# TECHNICAL SERVICE BULLETIN

## MT88 Manual Transmission - No 3rd Gear And/Or Grinding Noise Going Into 3rd And/Or 4th Gear

**23-2409**

This bulletin supersedes 23-2219. Reason for update: Incorrect or Missing Parts

Figure 1

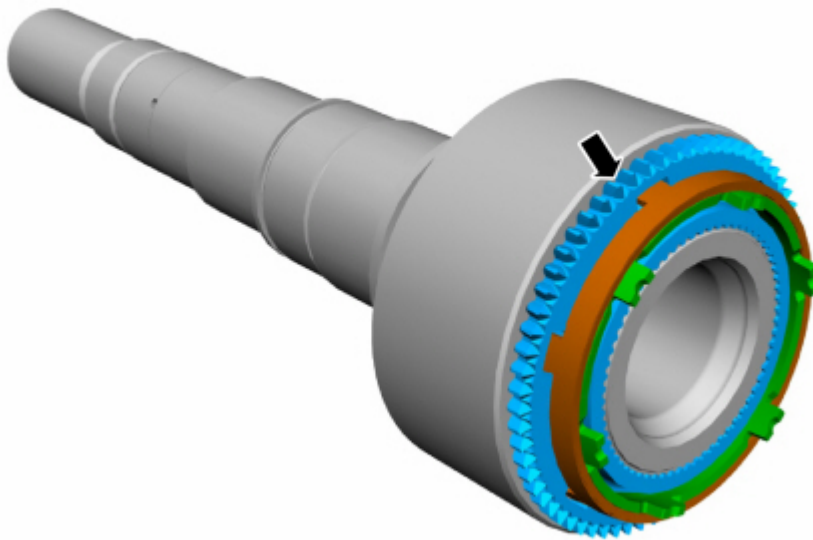
1. Remove the transmission from the vehicle. Refer to Workshop Manual (WSM), Section 308-03.
2. Disassemble the transmission. Refer to WSM, Section 308-03 > Disassembly > Transmission, Steps 1-34.
3. Remove the output shaft from the transmission case to gain access to the 3rd and 4th gears and synchronizer assemblies. Refer to WSM, Section 308-03 > Disassembly and Assembly of Subassemblies > Input Shaft, Steps 1-5.
4. Replace the following components and any associated damaged parts. Refer to WSM, Section 308-03.
  - 3rd gear.
  - Synchronizer assemblies for 3rd and 4th gears.
  - 4th gear synchronizer ring. (Figure 1)

**NOTE: 3rd gear is part of the input shaft. The 4th gear assembly is part of the output shaft assembly and does not require replacement, unless damage is found. In this transmission 4th gear uses a synchronizer ring to align the synchronizer assembly with the gear during shifts.**
